3/31/09	Added General Note (F)
DATE	REVISION	
STATE OF HAWAII DEPARTMENT OF TRANSPORTATION HIGHWAYS DIVISION BRIDGE GENERAL NOTES INTERSTATE ROUTE H-1 EXTENSION AND REPAIR OF SCHOOL STREET ON-RAMP RETAINING WALL Project No. H11-01-08 Scale: As Noted Date: Feb., 2009

3/31/09	Revised and/or Added Callouts and Legend
DATE	REVISION
STATE OF HAWAII DEPARTMENT OF TRANSPORTATION HIGHWAYS DIVISION RETAINING WALL REPAIR and EXTENSION EXISTING SITE PLAN INTERSTATE ROUTE H-1 EXTENSION and REPAIR of SCHOOL STREET ON-RAMP RETAINING WALL Project No. H11-01-08	
Scale: As Noted	Date: Feb, 2009
SHEET No. Q3 OF 34 SHEETS

RETAINING WALL REPAIR and EXTENSION

STATE OF HAWAII
 DEPARTMENT OF TRANSPORTATION
 HIGHWAYS DIVISION
RETAINING WALL REPAIR
 WALL "H" & "O" DETAILS
 INTERSTATE ROUTE H-1
 EXTENSION AND REPAIR OF
 SCHOOL STREET ON-RAMP RETAINING WALL
 Project No. H11-01-08

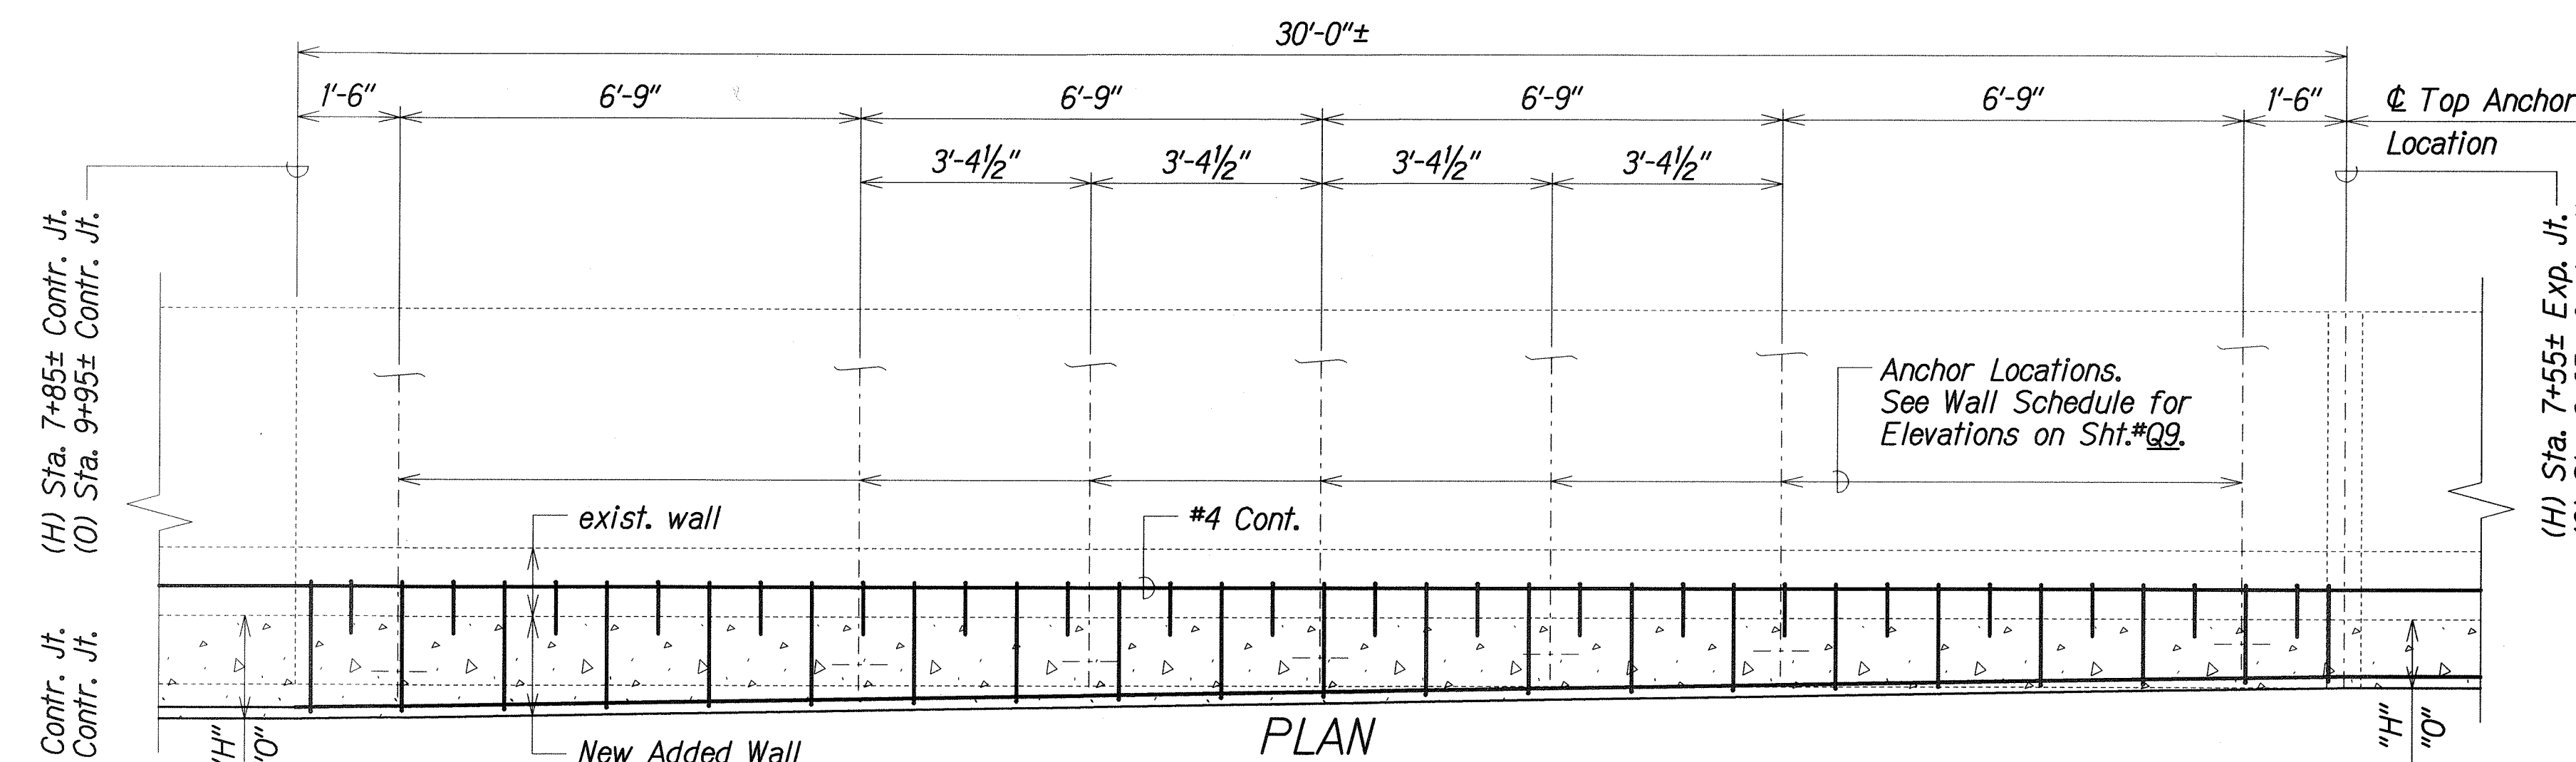
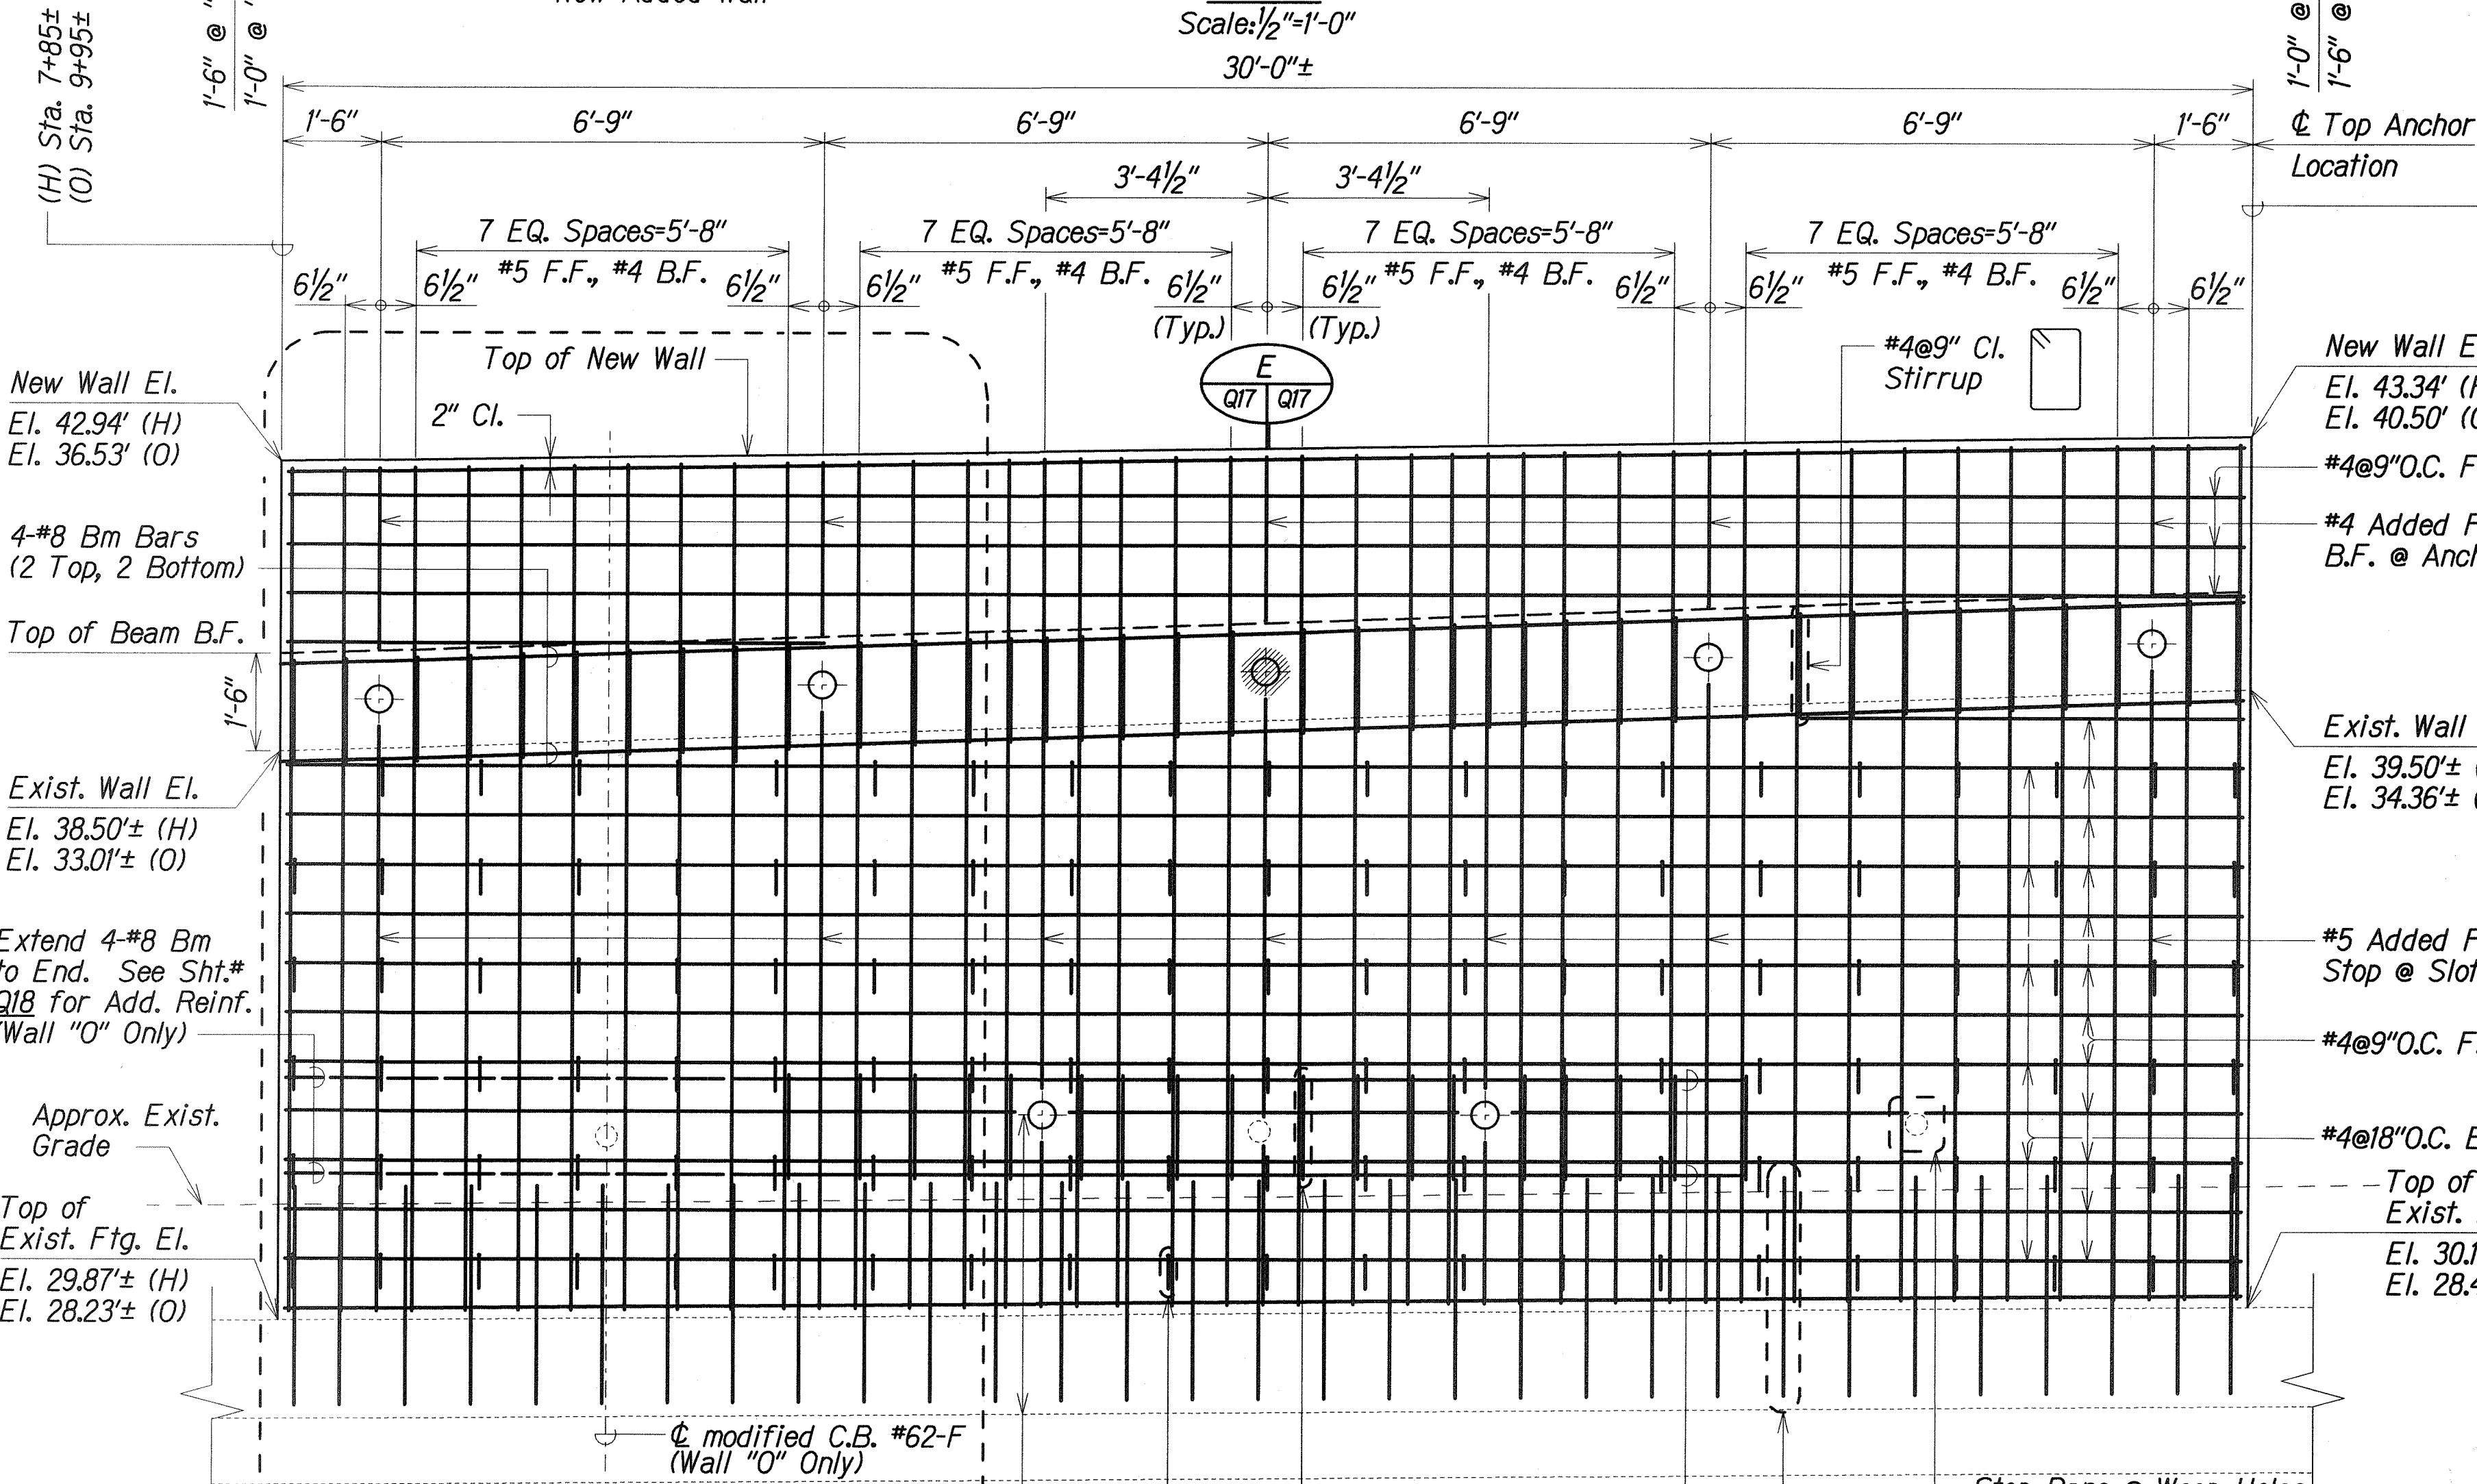
DATE	REVISION
3/31/09	Revised Detail Designation
